Technical Bulletin

TB No. AA-15074

SUBJECT: 429 HUMS Upgrade

PARTS AFFECTED: **Aeronautical Accessories Health and Usage Monitoring System (HUMS) Kit**
P/N 429-260-001

FIGURE 8 – HUM PWR AND SIGNAL GROUND SCHEMATIC

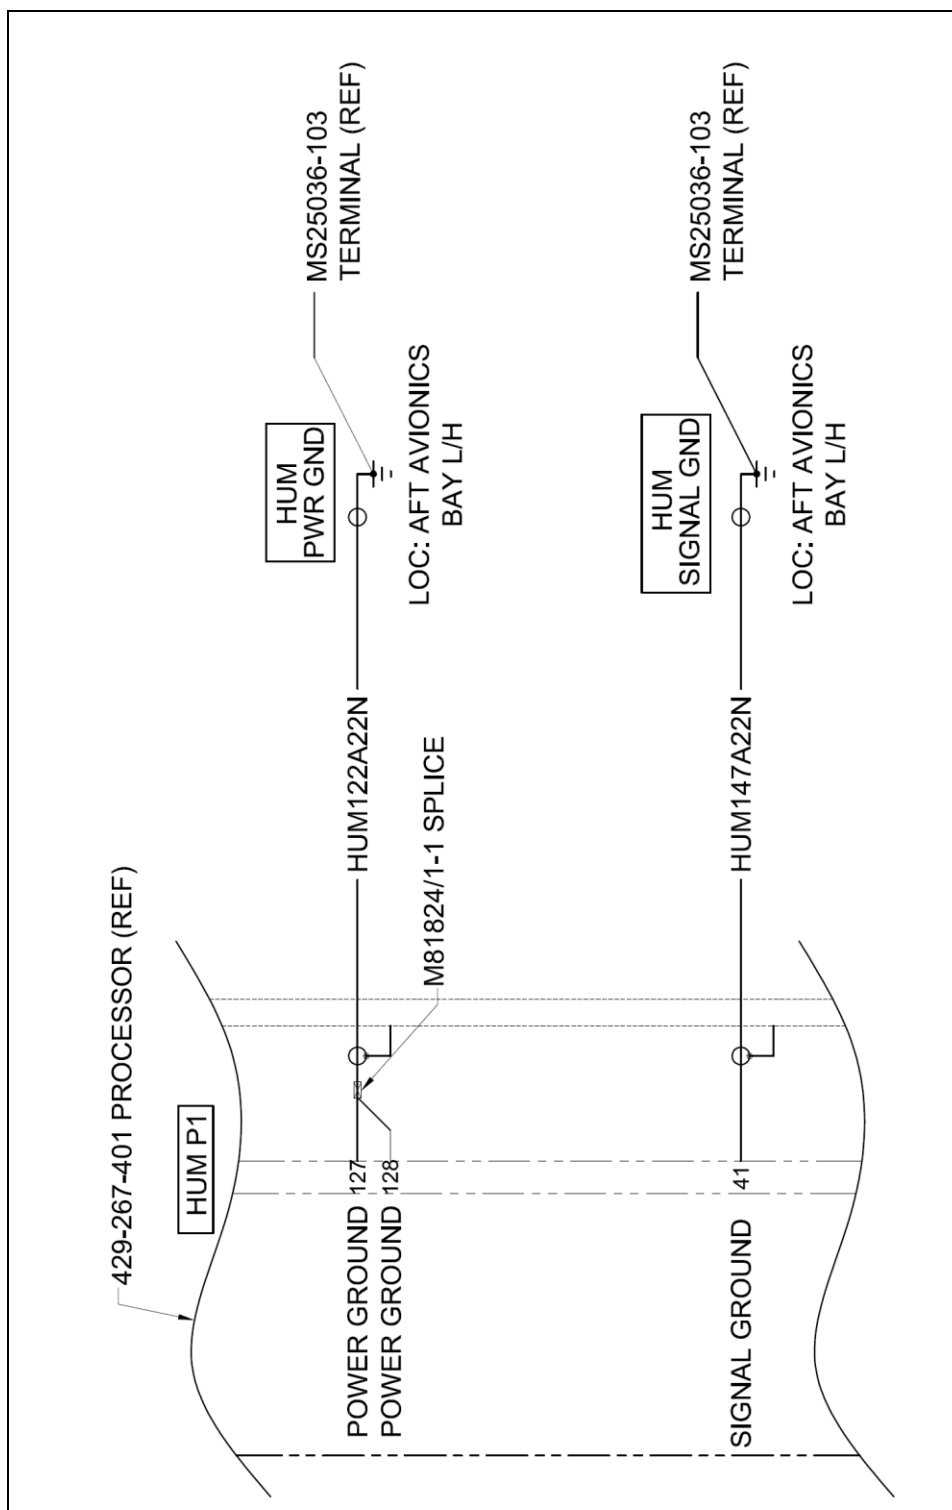
6. Ensure proper electrical bond of 2.5 milliohms or less per AC43.13-1, Chapter 11, Section 15.
7. Install HUM147A22N Signal ground wire as shown respectively in Figure's 5 & 6 and per View B-B, in Figure 7 and Figure 8.
